ALERT SERVICE BULLETIN

NO. 205B-00-33
DATE 10-19-00
PAGE 1 of 3

SUBJECT: MAIN HYDRAULIC SERVO ACTUATOR ROD
END LOCK WASHER, INSPECTION AND
REPLACEMENT OF

FLIGHT CONTROLS – HYDRAULIC SERVO ACTUATOR INSPECTION FOR DAMAGED LOCKING WASHER

Figure 1

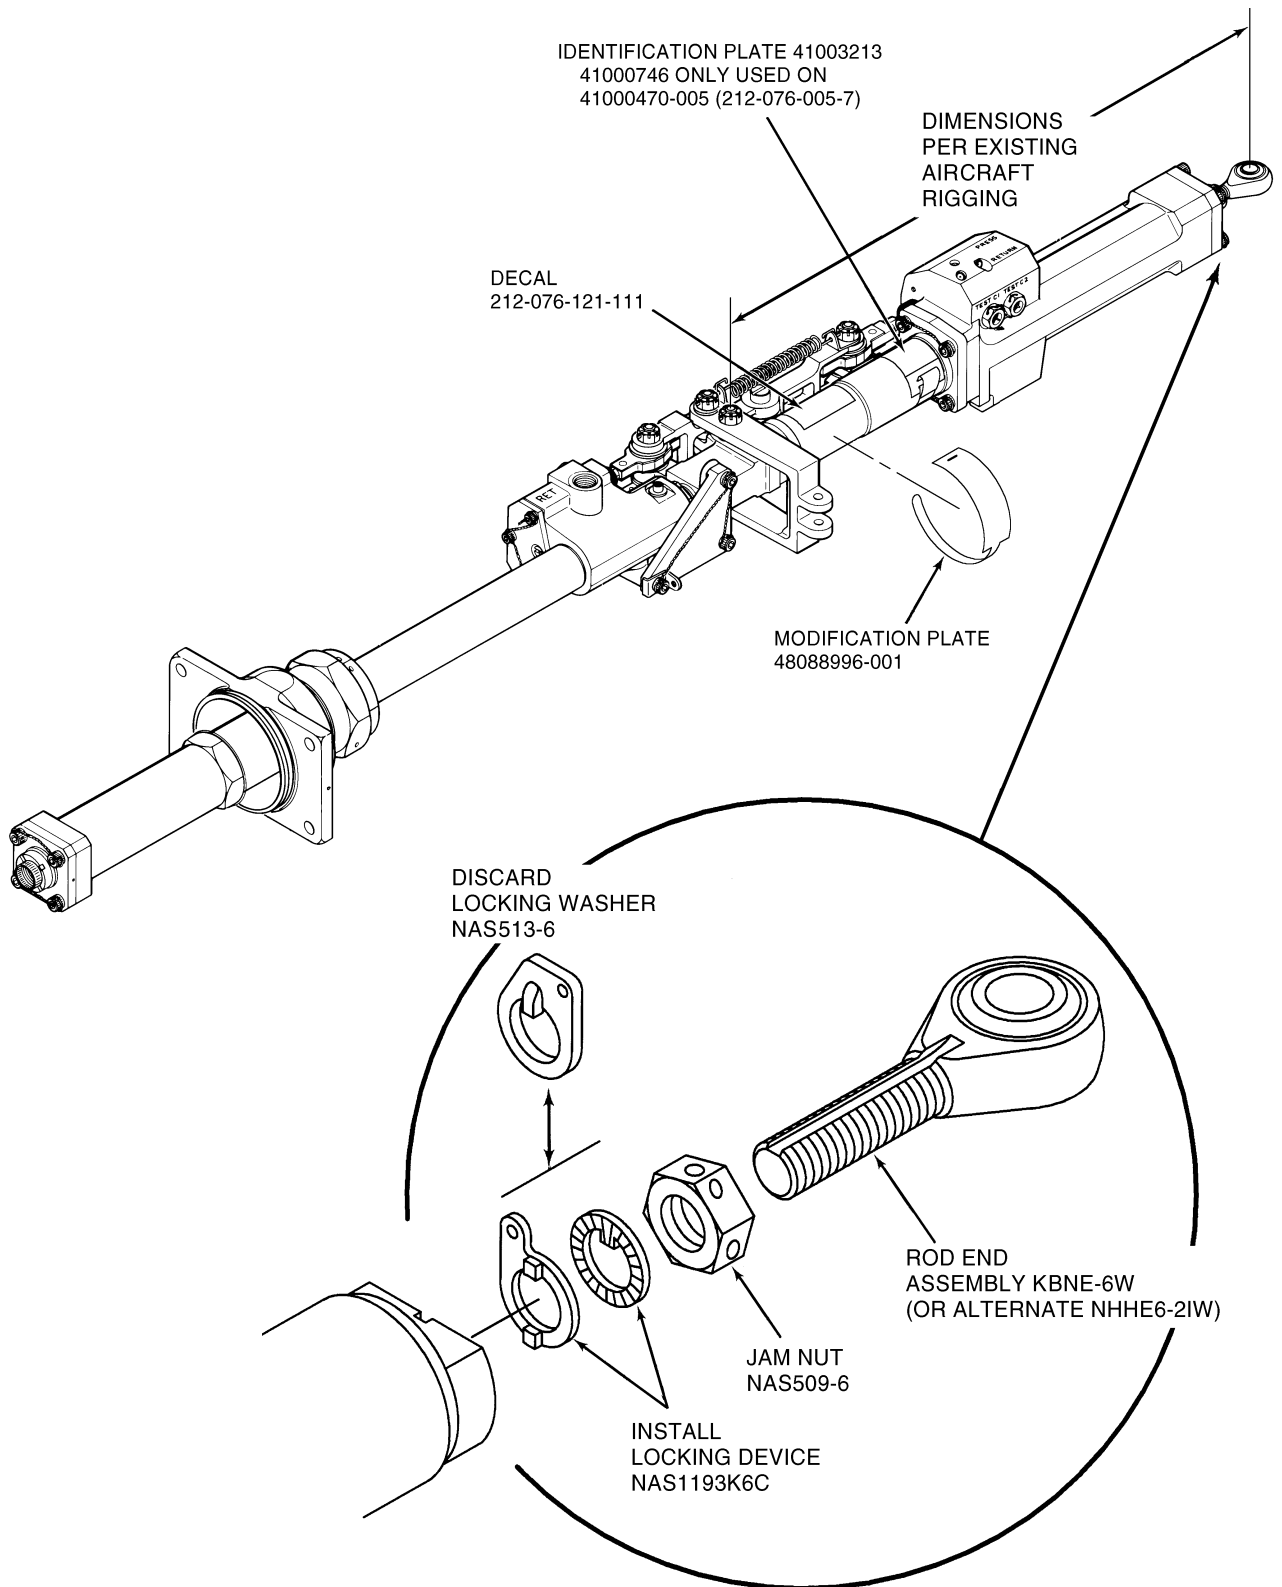
A customer recently discovered a damaged locking washer that had allowed the piston to back itself out of the locking jam nut (Figure 1). This condition prevented the aircraft from taking off and presented a Safety of Flight condition. Bell Helicopter's subsequent investigation determined that all existing locking washers NAS513-6 used on applicable actuators shall be replaced with new locking devices NAS1193K6C.

- A. Within 25 hours of receiving ASB, inspect locking washers NAS513-6 as follows:
- (1) Without removing actuator from aircraft, gain access to locking washer (Figure 1).
 - (2) Visually inspect locking washer to ensure it is not broken. Tab shall be in groove of rod end assembly. Immediately replace any locking washer whose tab is twisted or hanging askew.

- (2) Disconnect rod end assembly from aircraft attachment point.
 - (3) Bottom piston in cylinder, then measure dimension from centerline of rod end assembly to centerline of pivot point for input lever assembly (Figure 1). Record dimension for later use.

- (7) Carefully install new 2-piece locking device NAS1193K6C onto rod end assembly. Refer to Figure 1 and the following substeps:
 - (a) Install round ring onto threaded rod so that tab fits into groove on rod end and serrated side faces away from jam nut.

- (b) Install oblong ring onto threaded rod so that serrated side will engage serrated side of round ring.
- (8) Install rod end assembly into threads of piston assembly. With piston assembly bottomed in cylinder assembly, establish the same dimension that was recorded in step 3.

- (9) Slide oblong ring (part of new locking device NAS1193K6C) so that two locking tabs fit into slots on end of piston assembly. Slide round ring (also part of new locking device NAS1193K6C) to engage oblong ring.
